Memorandum

Subject: THP No. 1-03-173 SCR
Hydrologic Review

This memorandum reports the results of a field inspection of THP No. 1-03-173 SCR held on March 11, 2004. This was a focused Pre-Harvest Inspection (PHI) inspection that followed two previous PHIs and took place prior to the CDF Second Review of the THP. It is limited to comments regarding the Class II watercourse protection zone. Specifically, I was asked to help evaluate if the trees marked in the Class II WLPZ were in the channel zone as defined by the California Forest Practice Rules, and to determine if the mark in the Class II was appropriate based on watershed processes such as large wood recruitment and bank stability. Participants for the field inspection held on March 11, 2004 included:

Figure 5. Annual peak discharges for the Corralitos Creek at Freedom USGS gaging station

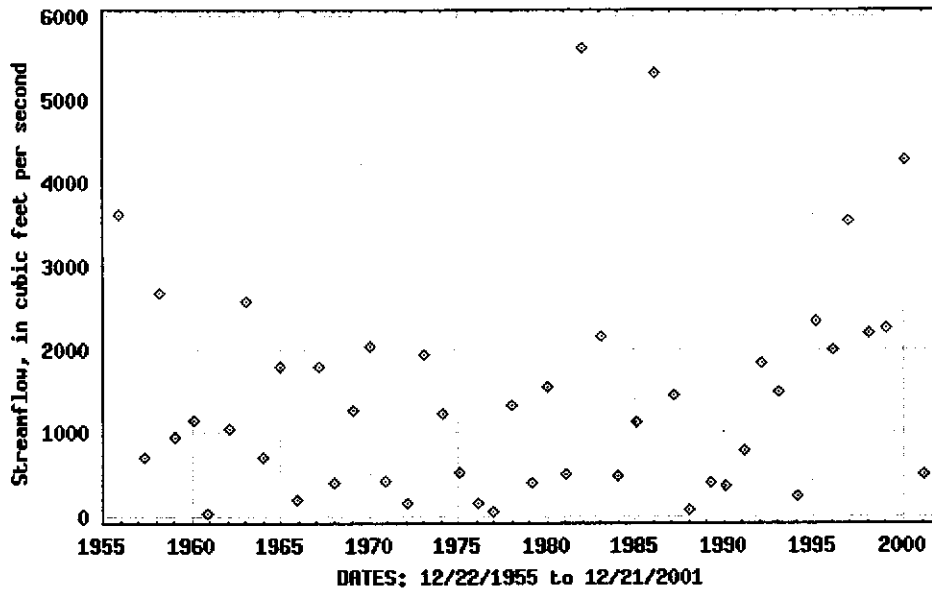
At tree site 1, where we began our field observations, we estimated that the elevation of the water of a riffle area would be approximately 12 to 14 inches higher than the depth currently present, and two times this depth would be 24 to 26 inches above the existing water elevation. The marked redwood tree (approximately 30 inches at dbh) was found to be considerably higher than this on the hillslope. Therefore, we concluded that this tree was not in the channel zone. No sediment marks were observed on the tree from past flood events. Four floods of 20 year recurrence interval or higher have occurred in the Corralitos Creek drainage since 1982 (see Figures 5 and 6, and the following discussion section).¹
